AGENDA
PLAN COMMISSION
Board Room, 3rd Floor
Arlington Heights Village Hall, 33 S. Arlington Heights Rd.
Arlington Heights IL 60005
September 24, 2025
7:30 PM

REPORT OF THE PROCEEDINGS OF A PUBLIC HEARING
 BEFORE THE VILLAGE OF ARLINGTON HEIGHTS
 PLAN COMMISSION

RE: 3125 NORTH WILKE ROAD-UNIT F - GOLD STAR MASSAGE - PC #25-009
 PLANNED UNIT DEVELOPMENT AMENDMENT FOR A LAND USE VARIATION
 TO ALLOW A MASSAGE ESTABLISHMENT IN M-1 DISTRICT

CHESTNUT WOODS
SUBDIVISION
1920 N CHESTNUT AVE.
ARLINGTON HEIGHTS, IL

PLATE RESTRICTOR DETAIL: ELEVATION

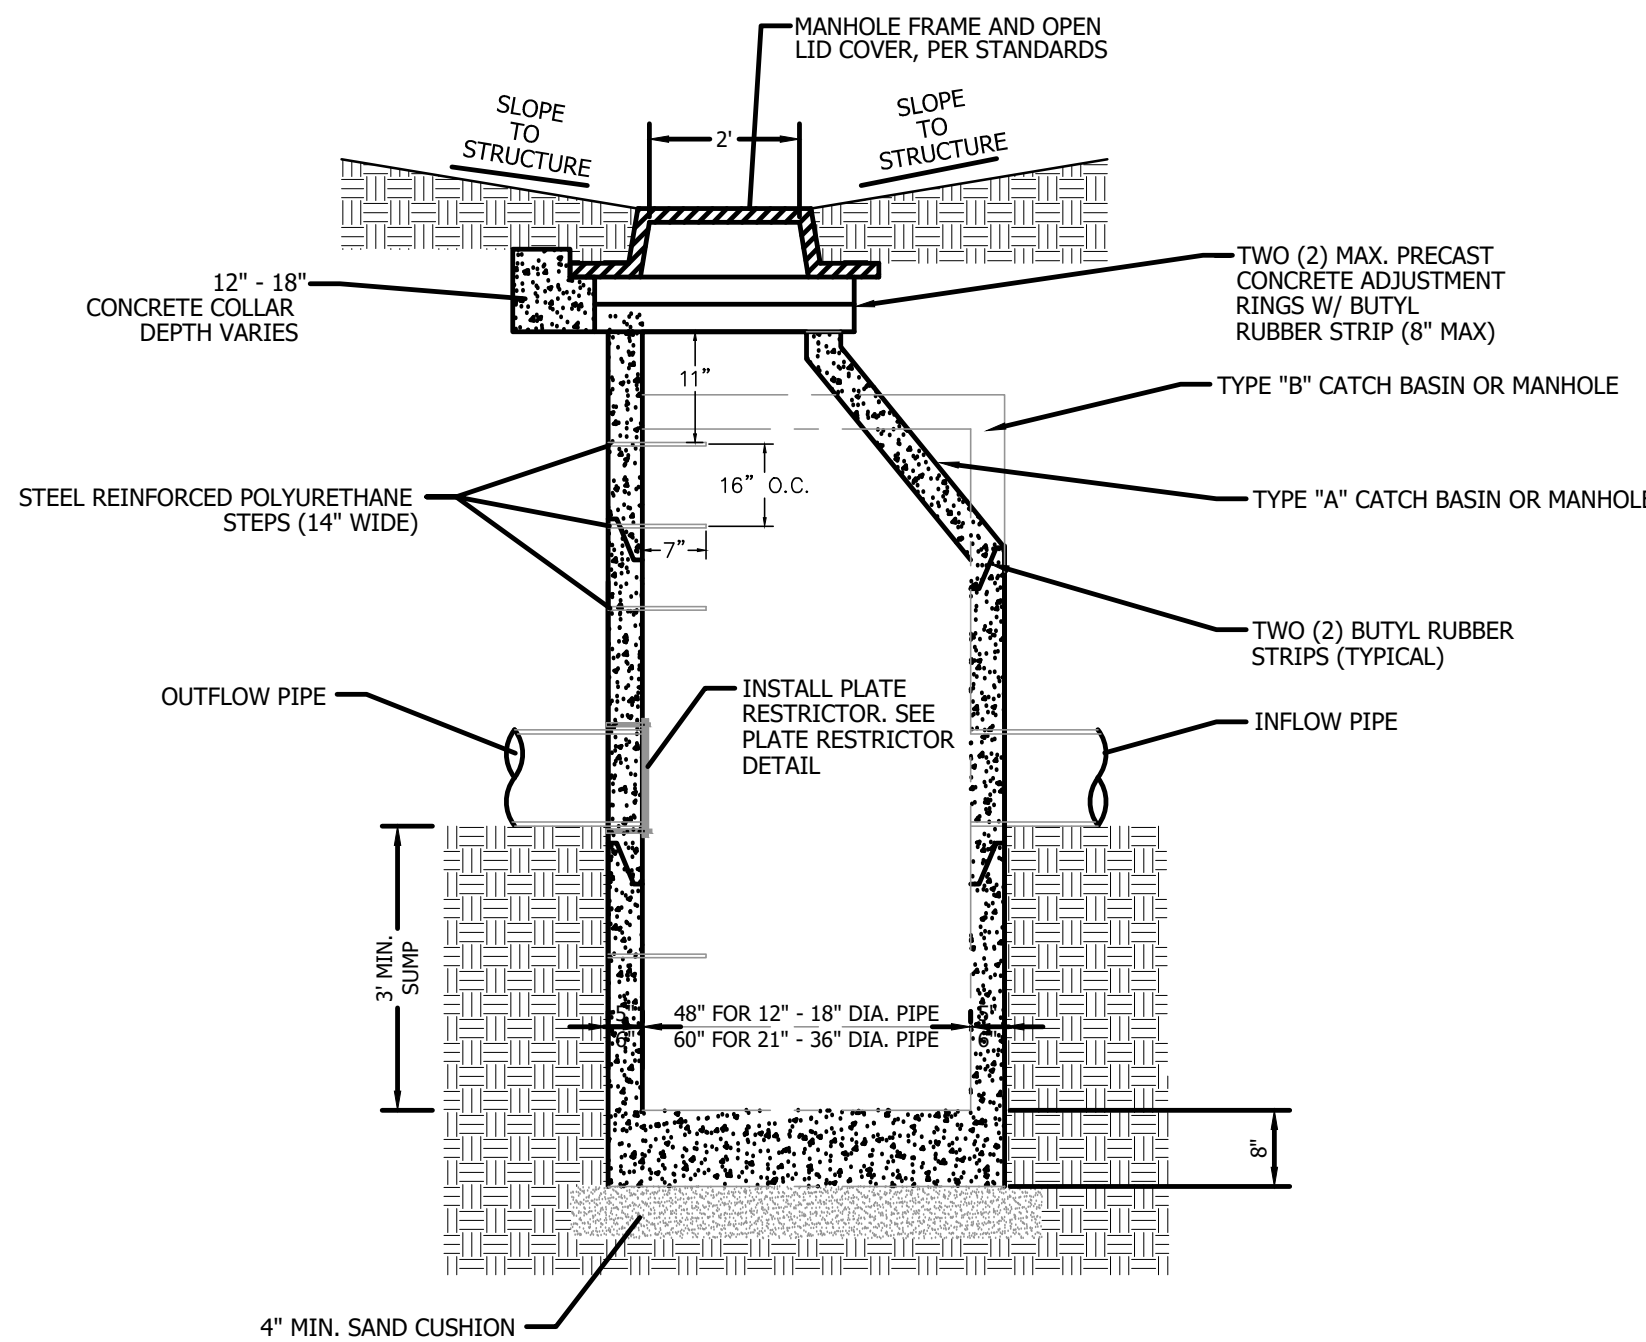
b. Provide a removable hood over the restrictor. NOTE 5 ADDED ON SHEET 4.

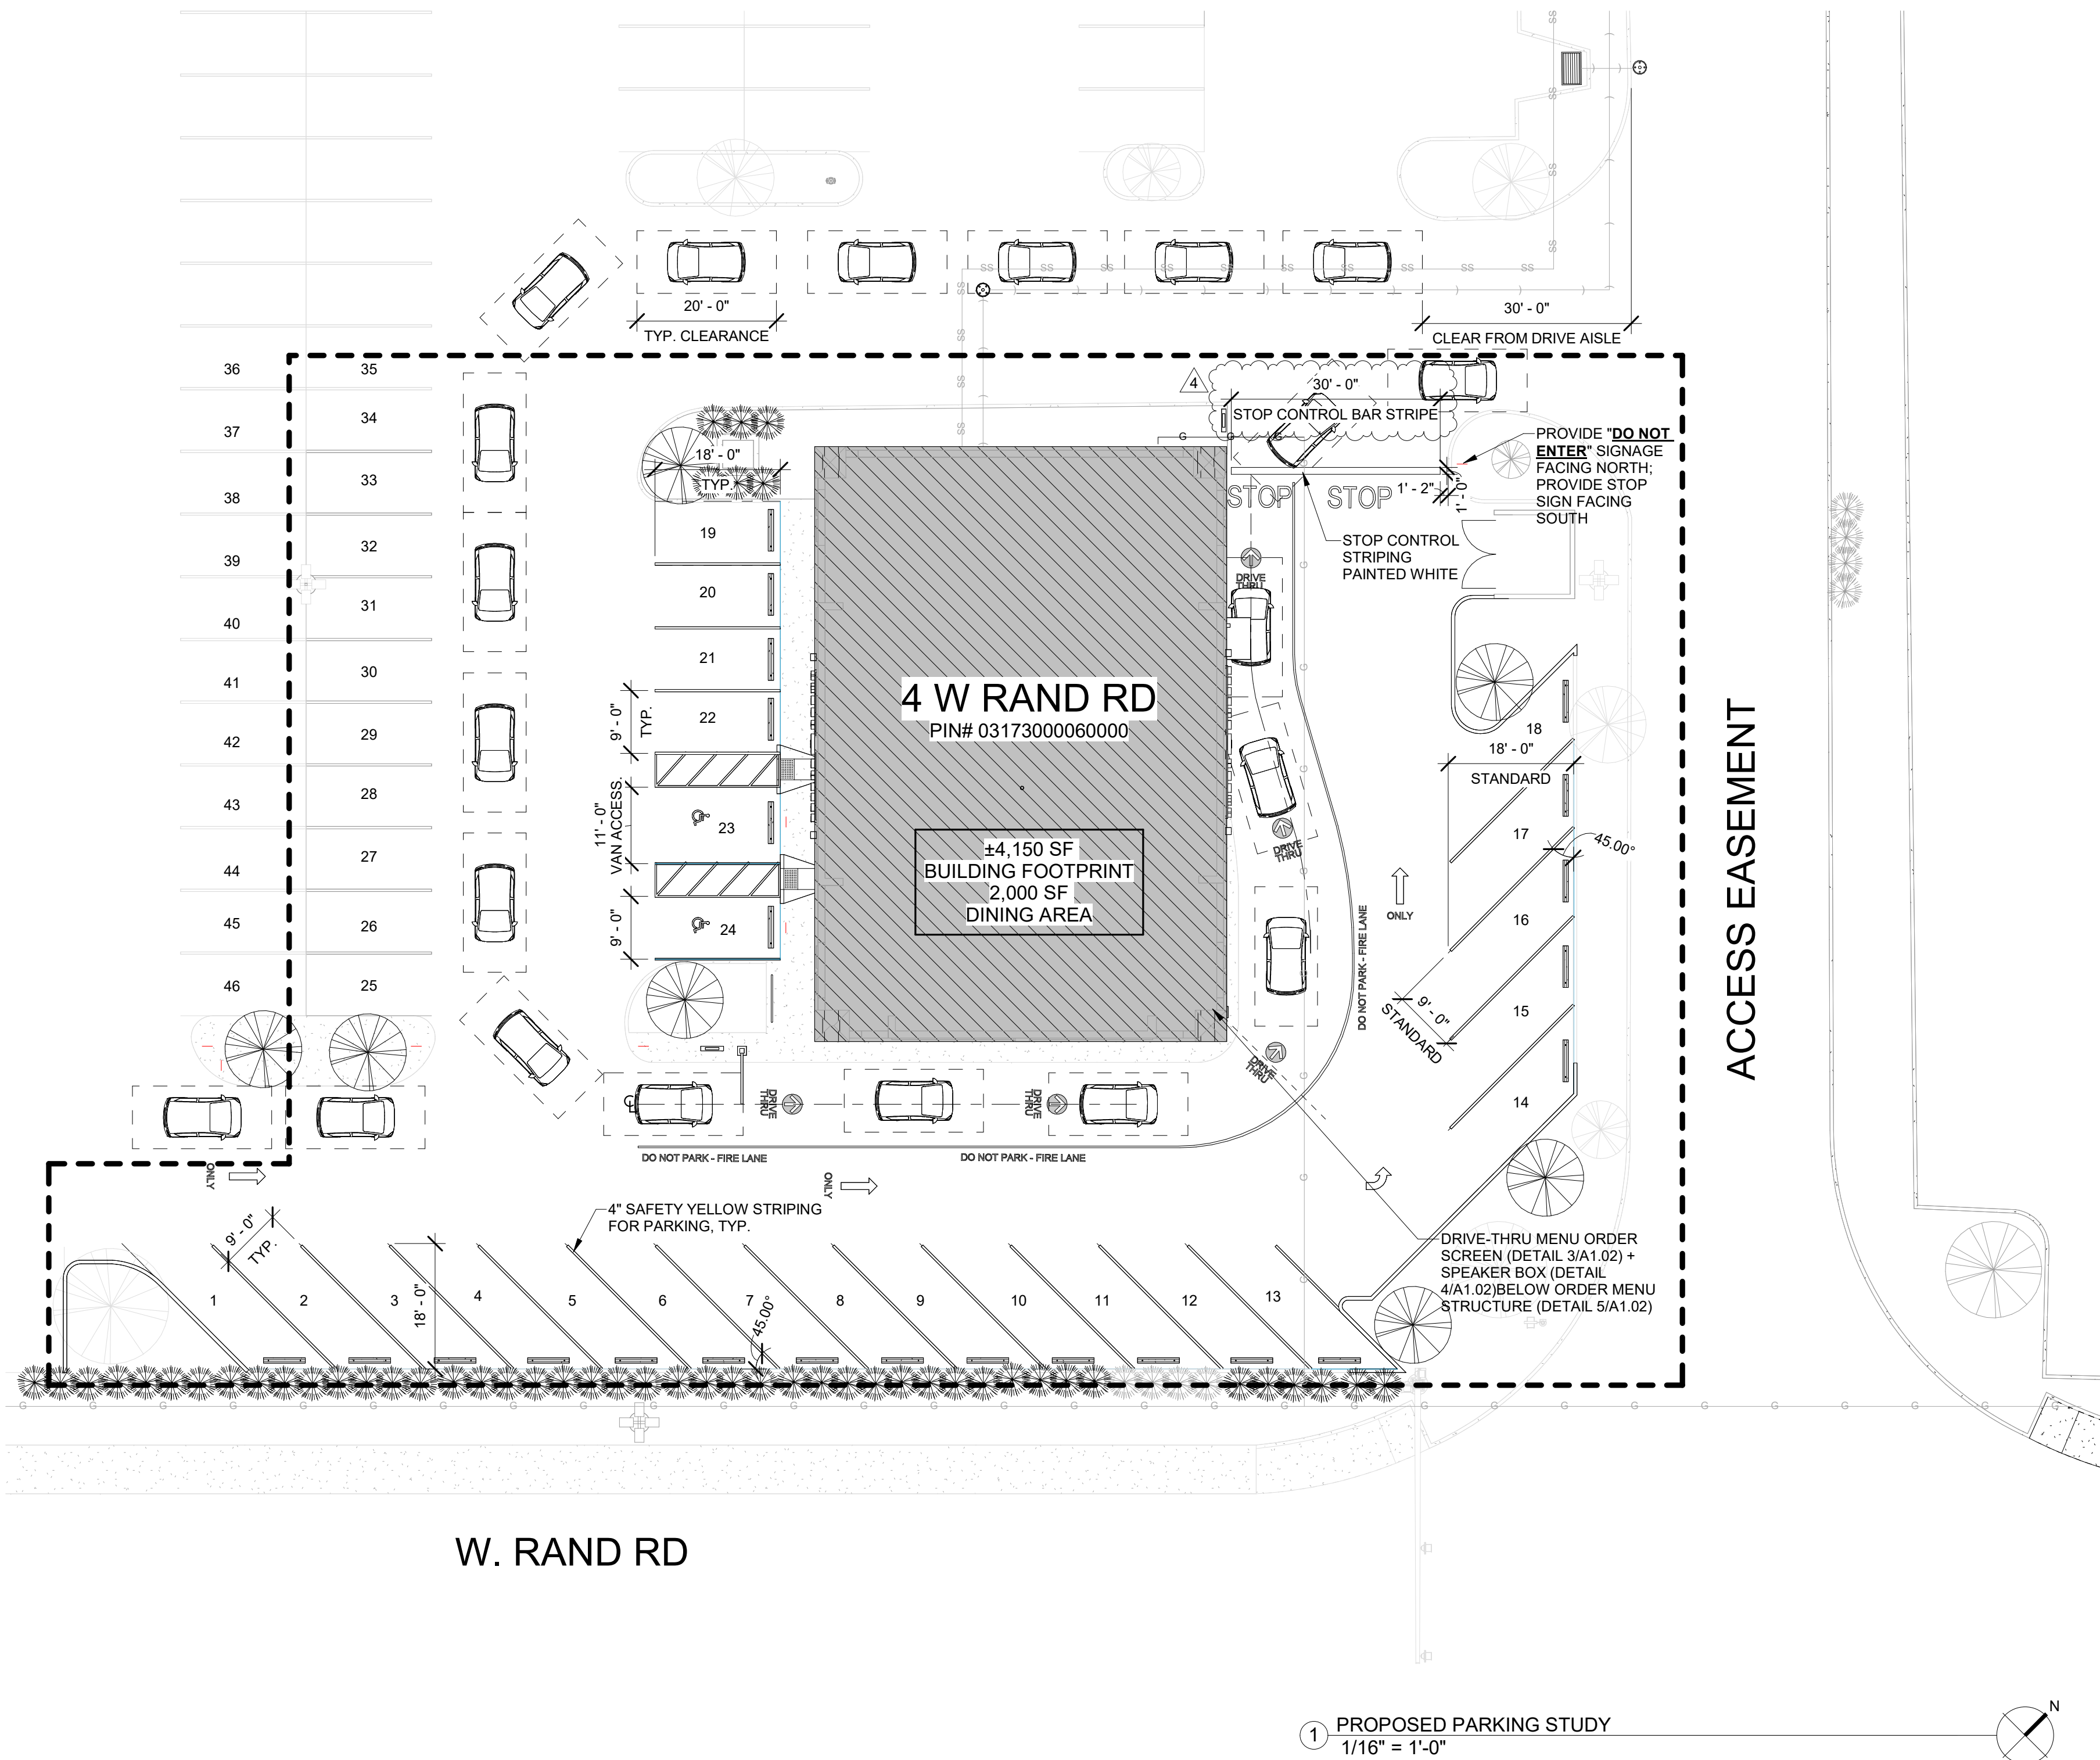
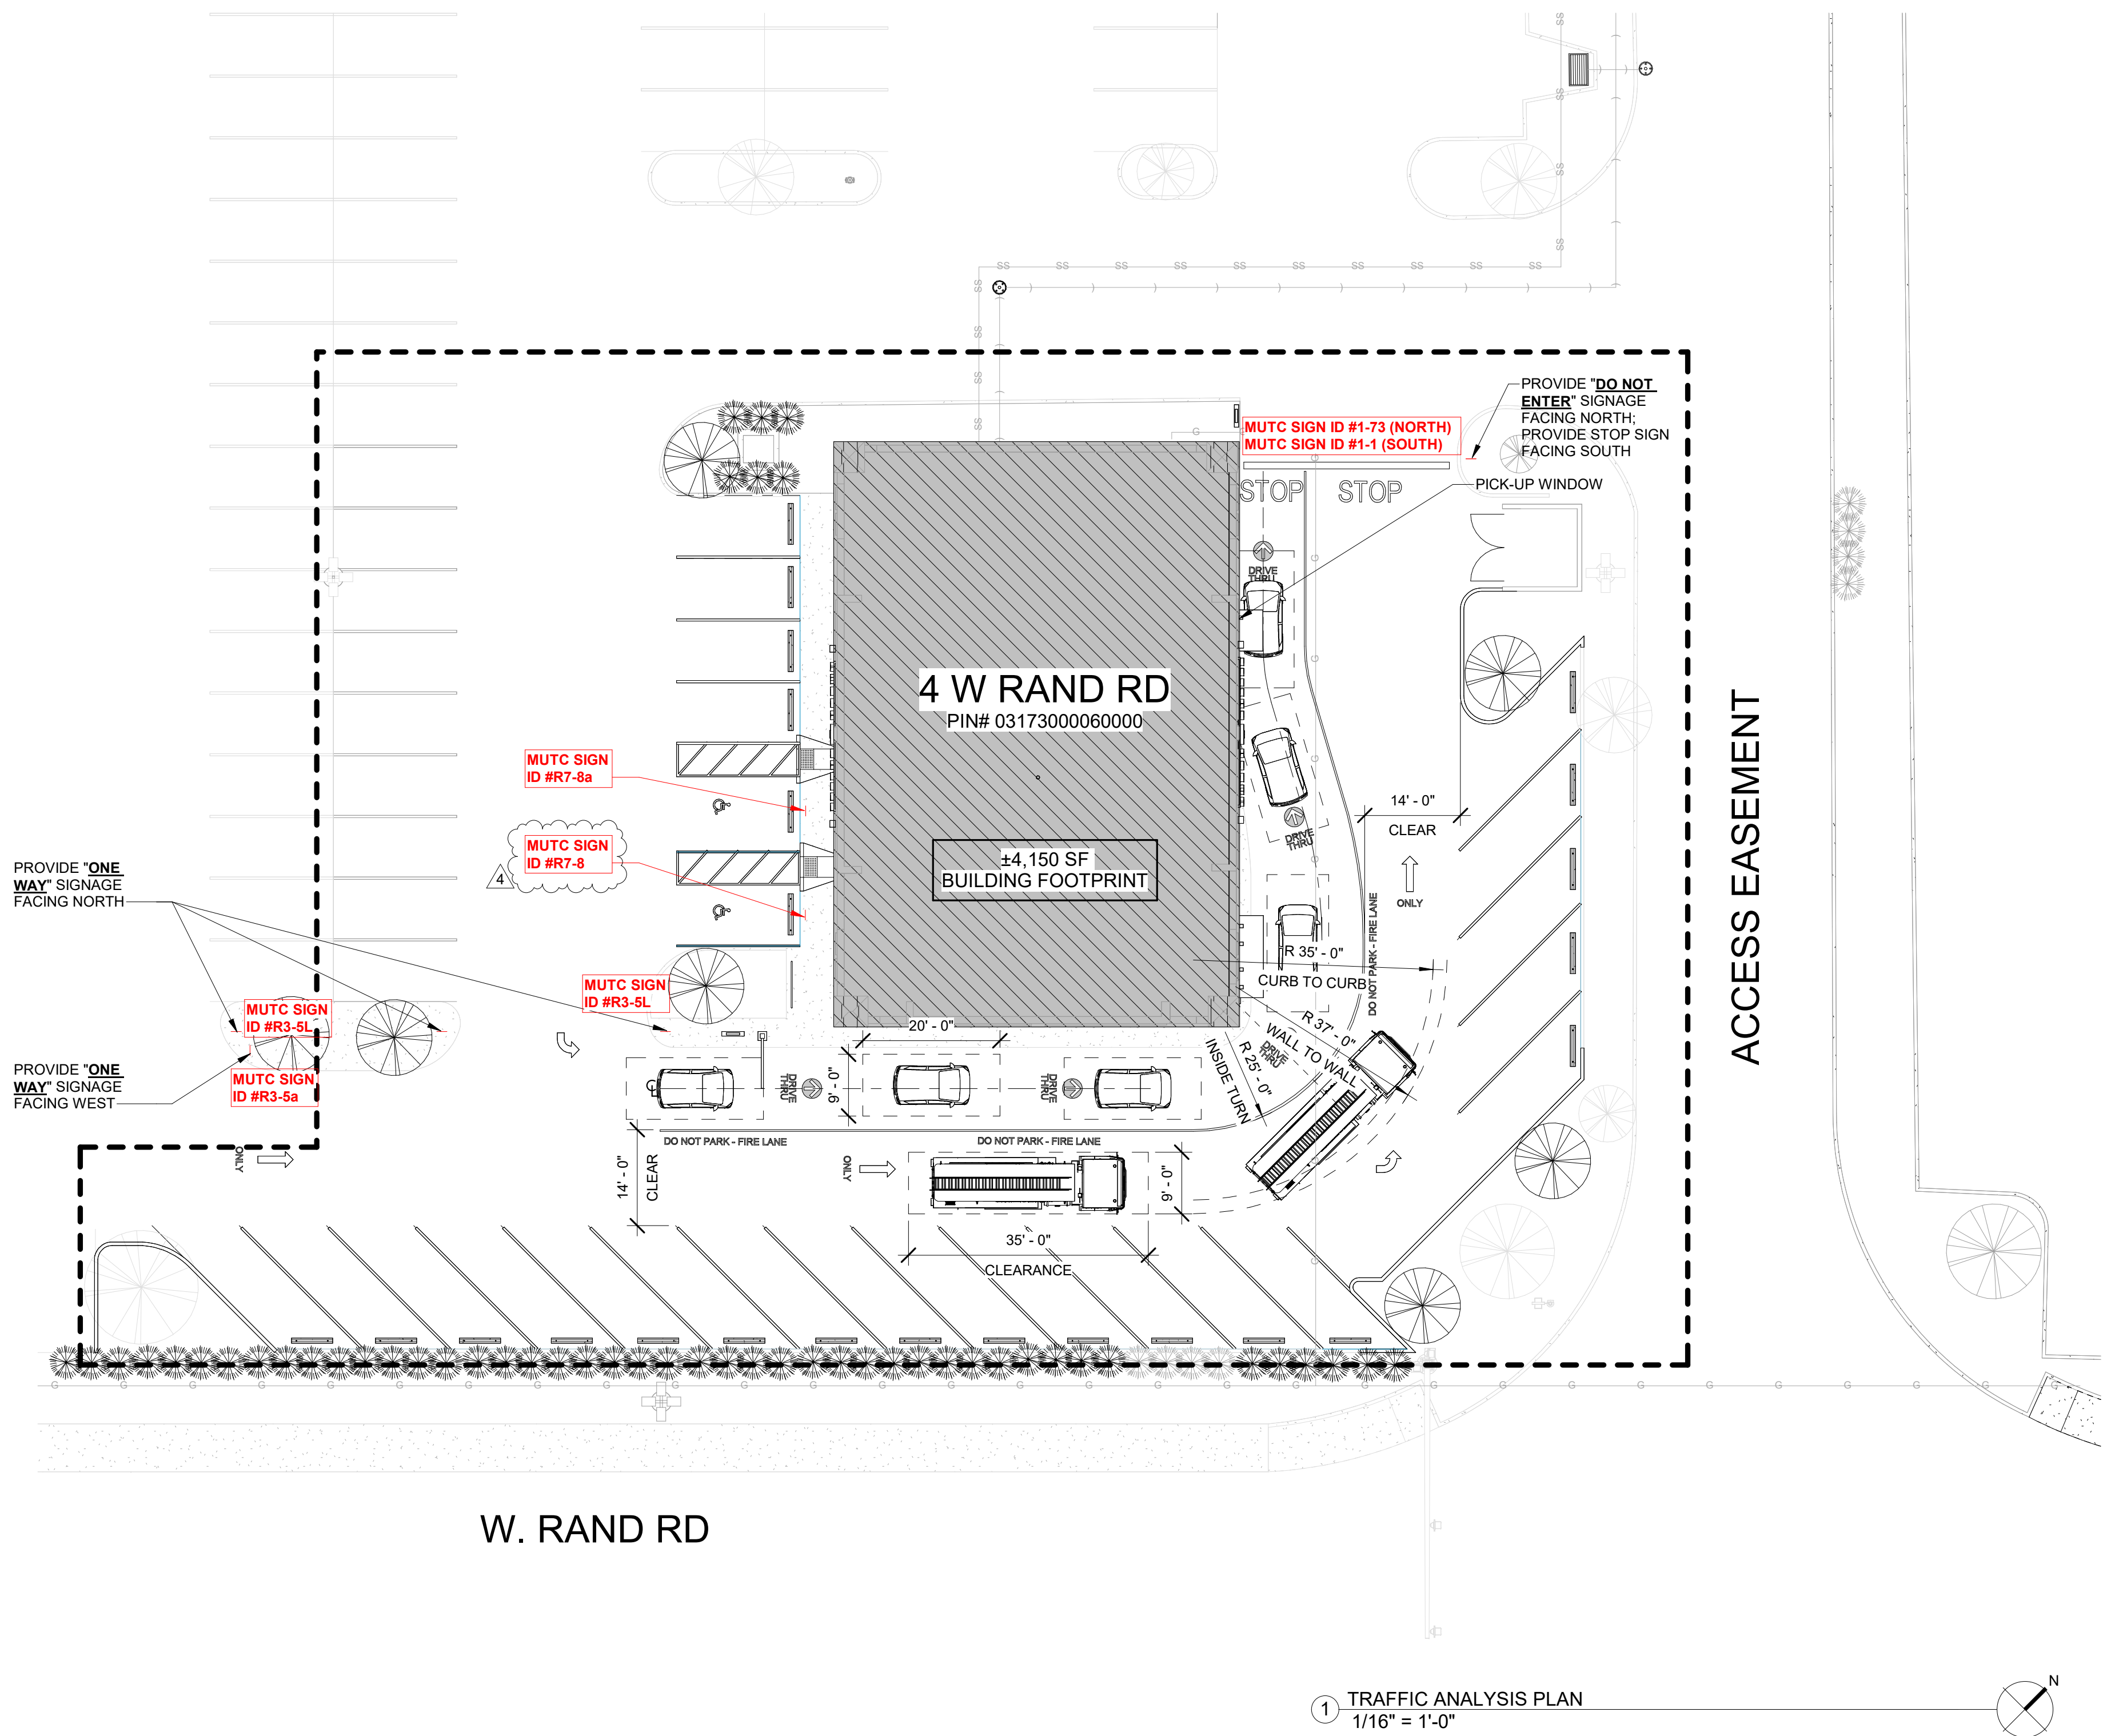
14		14.INCOMPLETE. Provide an exhibit to engineering scale showing the turning path of the Fire Department's responding vehicle, in this case Engine 114. Exhibit must show front and rear wheel paths and the extent of the front and rear overhangs, as provided in an "Autoturn" exhibit. The vehicle shall be shown maneuvering through the site in all possible directions of travel. Attached are the specifications for the tower apparatus.	Nanci Julius	Provided in new sheet A1.01B labeled TRAFFIC ANALYSIS
15		15.COMPLETE. If an exterior grease trap is required for the change in use for the building, an MWRD permit will be required. The MWRD permit determination letter has been provided, an MWRD permit is not required.	Nanci Julius	Acknowledged.
16		16.ITEMS a & b INCOMPLETE. Staff concurs with KLOA's recommendation to provide: a)Wayfinding signage to guide vehicles to the entrance of the drive-through lane. b)Vehicles exiting the drive-through lane should be under stop sign control. c)Provide a "Do Not Enter" sign placed at the exit of the drive-through lane facing north.	Nanci Julius	Has been previously provided on sheet A1.01 in Response #1. Provided further clarification in revised sheet A1.01. Also provided "One Way" signage at the southwest end just before entering the drive thru.

23		23.COMPLETE: Show one-way striping adjacent to the angled spaces.	Dan Osoba	Acknowledged.
24		24.INCOMPLETE: One-way signage is needed where the drive aisle changes from two- way to one-way. a. 2ND REVIEW: One-way signage needs to be provided at the southwest corner of the site where the drive aisle changes from two-way to one-way traffic.	Dan Osoba	Provided in revised sheet A1.01.

30		30.INCOMPLETE: Bicycle parking spaces are required with this application. Show the location and design of bicycle parking spaces (2 required) with your next submittal. Bicycle parking spaces shall comply with standards set forth in the Association of Pedestrian and Bicycles Professionals Bicycle Parking Guidelines Handbook. a. 2ND REVIEW: Bicycle racks were not provided or shown on the site plans for this submission.	Dan Osoba	Provided on revised sheet A1.01
END
